Re: Mega Drop Amusement Ride

Sub: Over the Shoulder Restraint

Cracking

The following is a repair procedure provided by FAM to repair any cracking of the over the shoulder restraint on the Mega Drop. The additional drawing details the area and further illustrates the repair method.

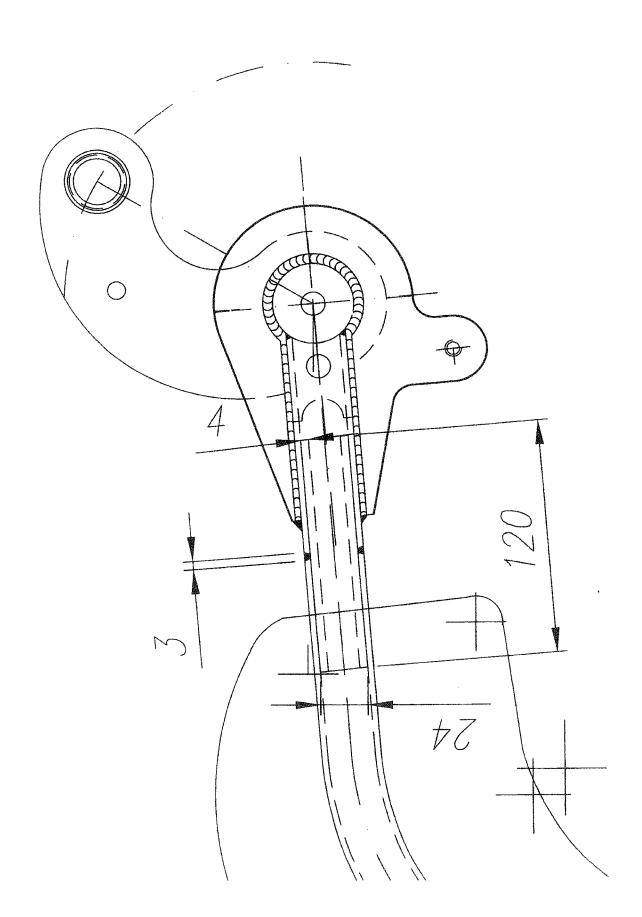
please find enclose the steps to repair the cracks and a schetch:

This is the first time we have such this problem on a mega drop and it seems strange because on this ride the forces on the lap bar are very low.

- 1) Cleane the cracks on each lap bar with the grinding machine.
- 2) Prepare internal reinforces for the lap bar: Hollow circle diameter 24 mm thickness 3 or 4 mm lenght 120 mm material S355JO.
- 3) Prepare the edges of the pipe of the lap bar at 20°.
- 4) Weld with basic electrode type E 7018 AWS 5.2.
- 5) Make a non destructive test on the weldings, (penetrant liquids).
- 6) Inspect the situation every day.
